ADDENDUM NO. 3

City of Tukwila, Washington S Boeing Access Road over Airport Way Bridge Seismic Retrofit Project

City Project No.: 91310407

DATE OF ADDENDUM ISSUE: March 31, 2020

C5
8 of 23

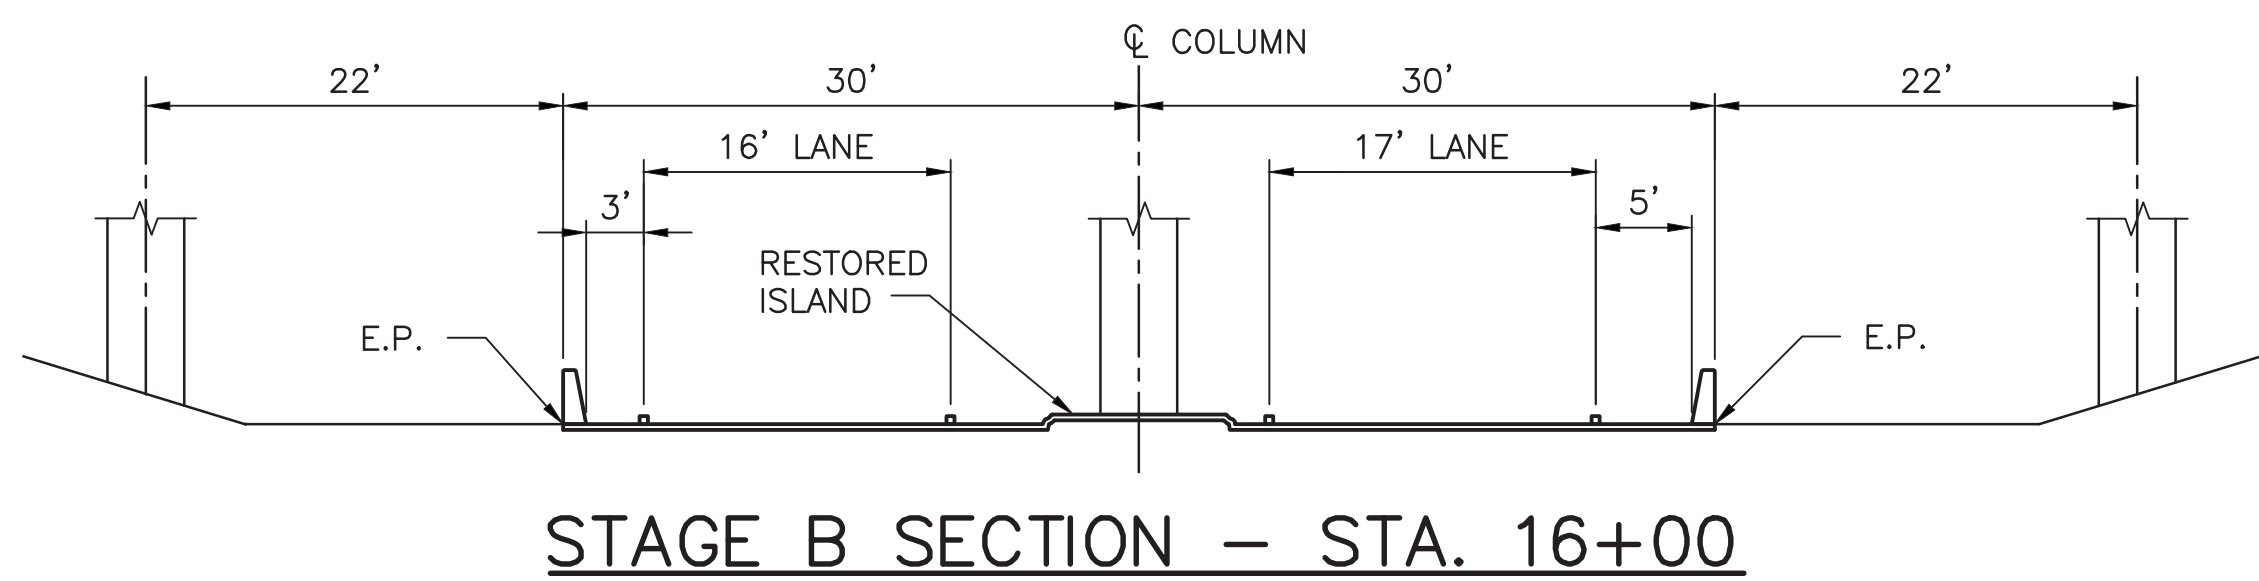
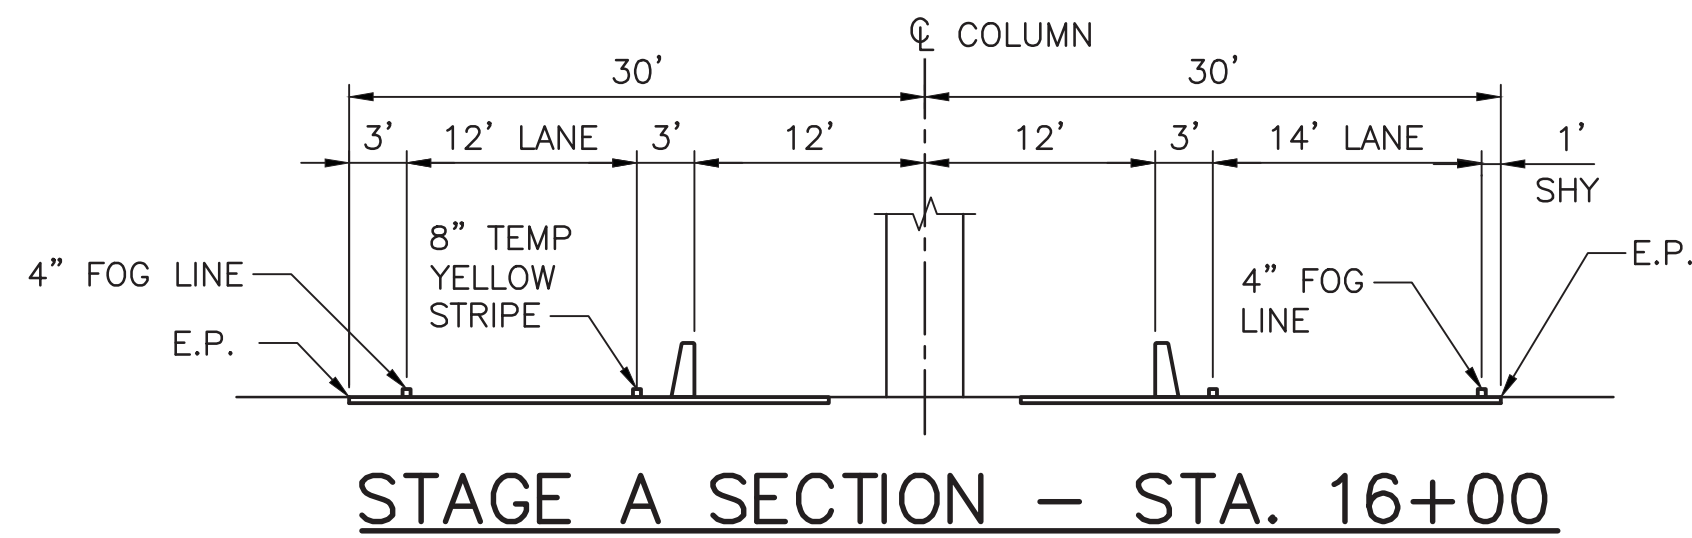
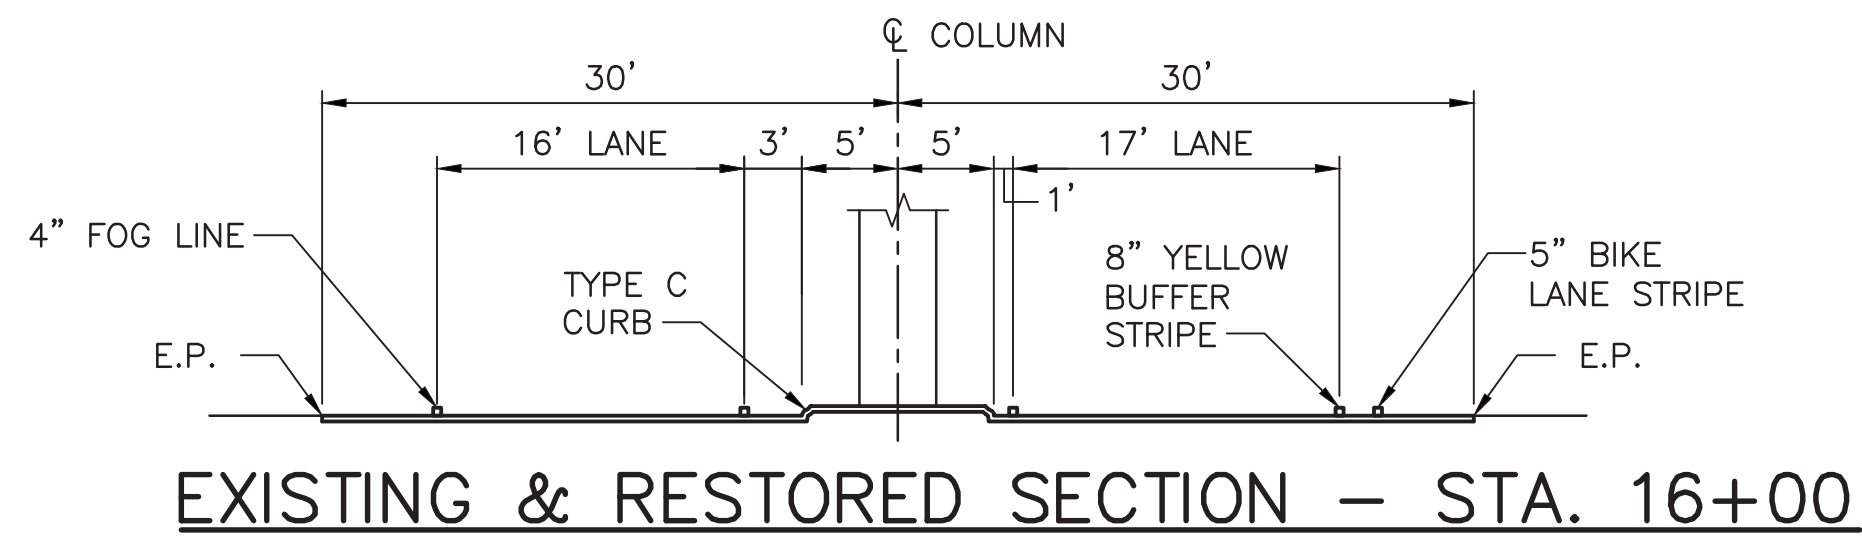
4. Plan Sheet 8 of 23:

DELETE Sheet 8 of 23 and REPLACE with the attached Sheet 8 of 23.

The following changes have been made:

- Removed lane closure and associated devices east of Southbound I-5 Offramp in westbound lane.

C6
9 of 23
File No. C6.dwg
Scale NTS
Date DEC. 2019

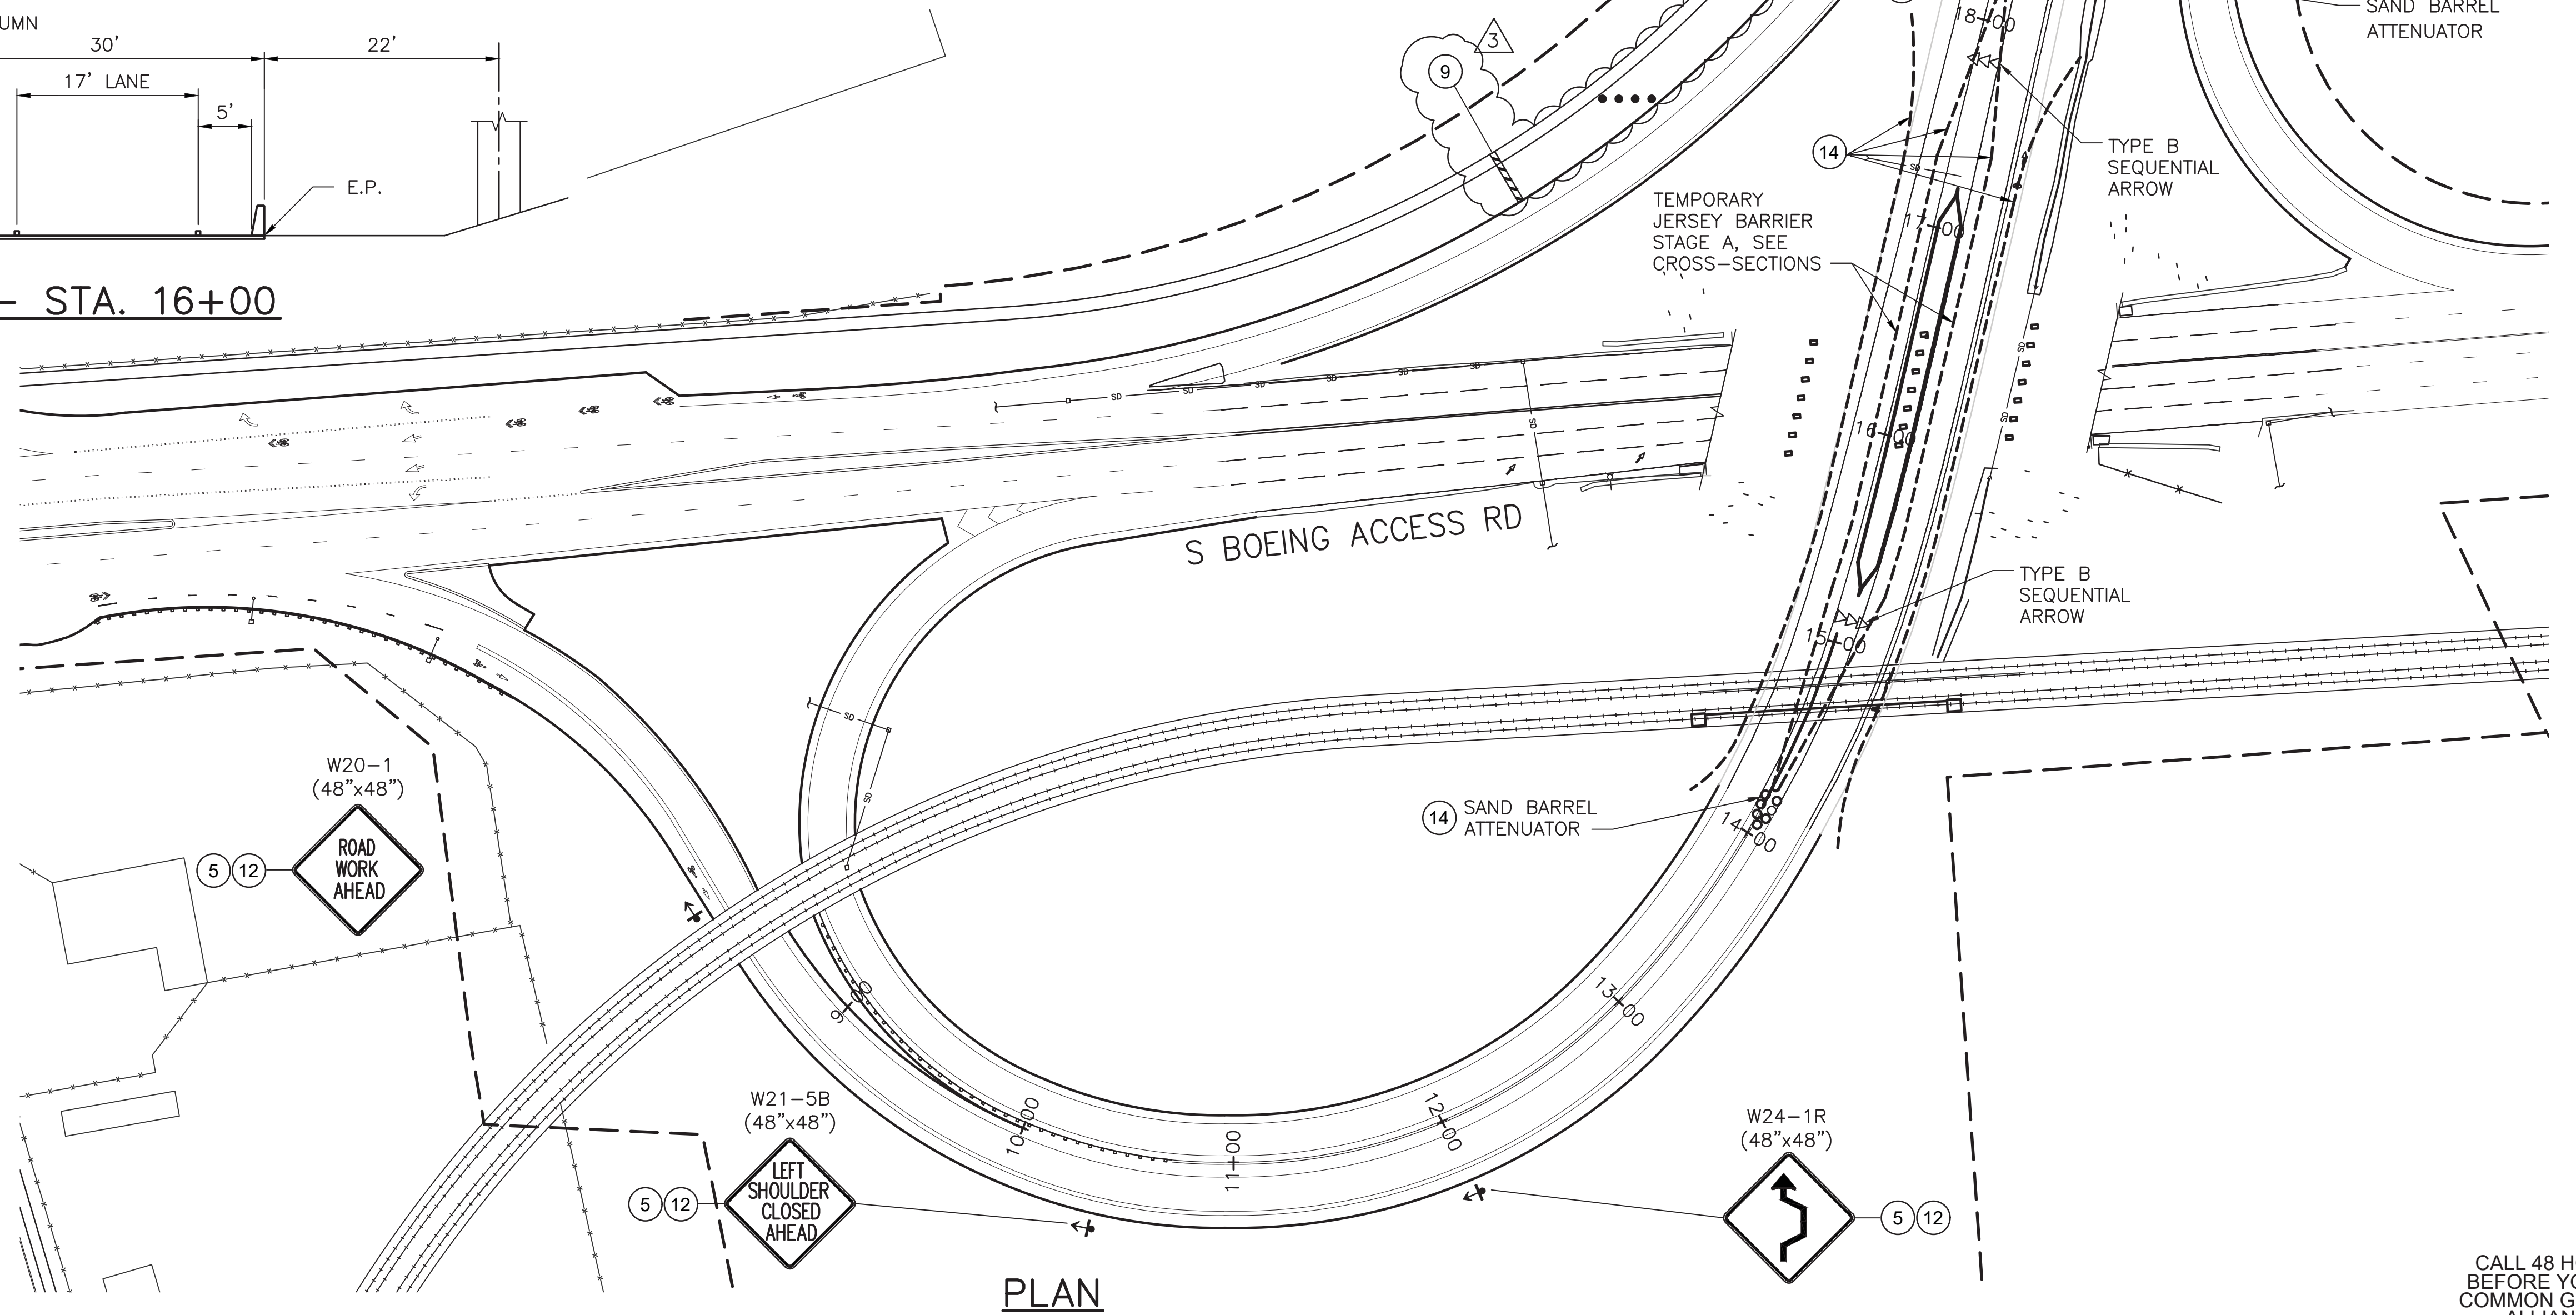
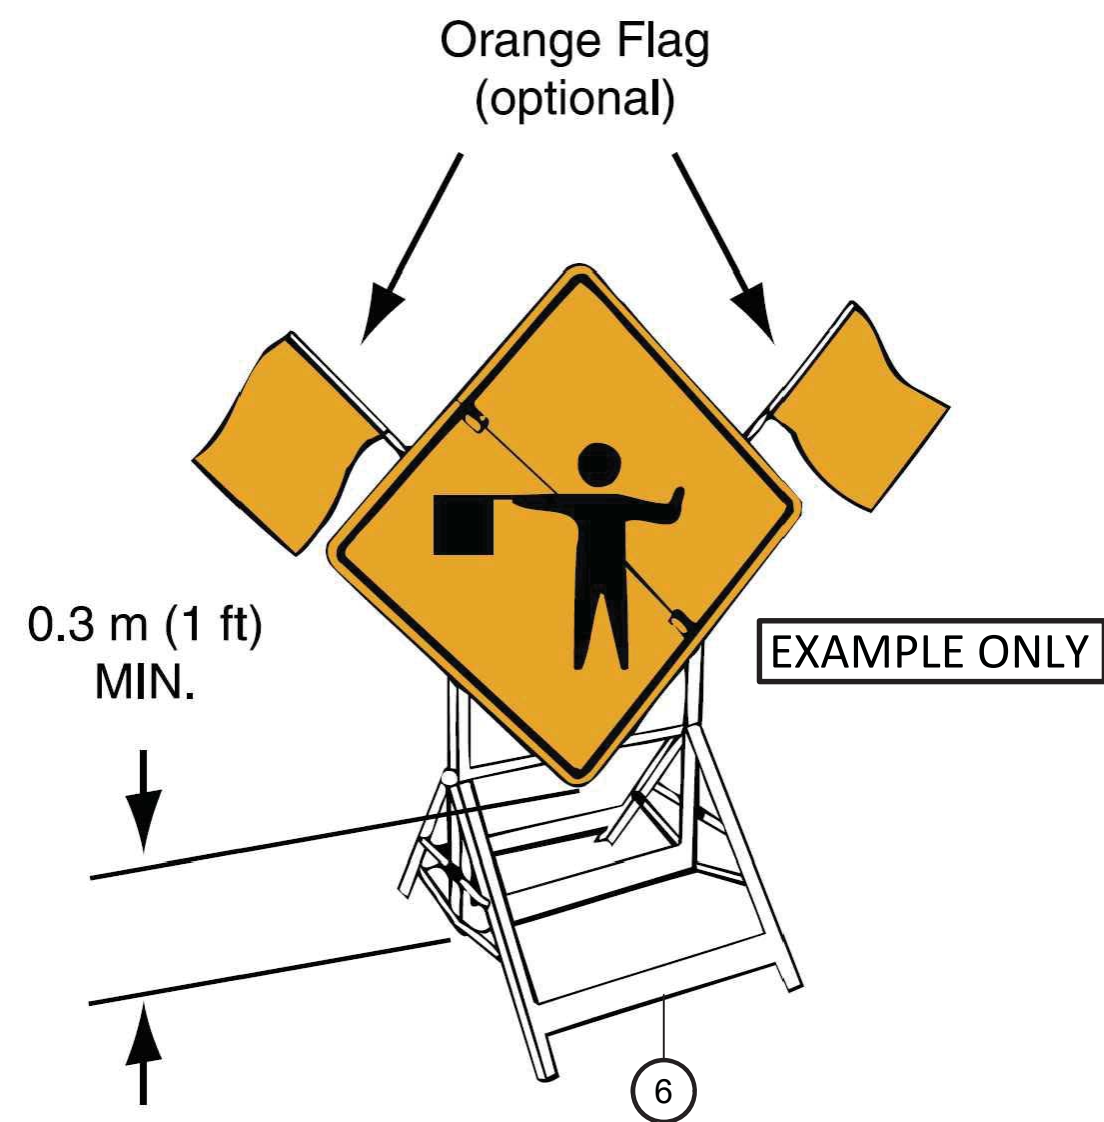
5. Plan Sheet 9 of 23:

DELETE Sheet 9 of 23 and REPLACE with the attached Sheet 9 of 23.

The following changes have been made:

- Added signs and devices for lane closure of westbound Airport Way ramp.
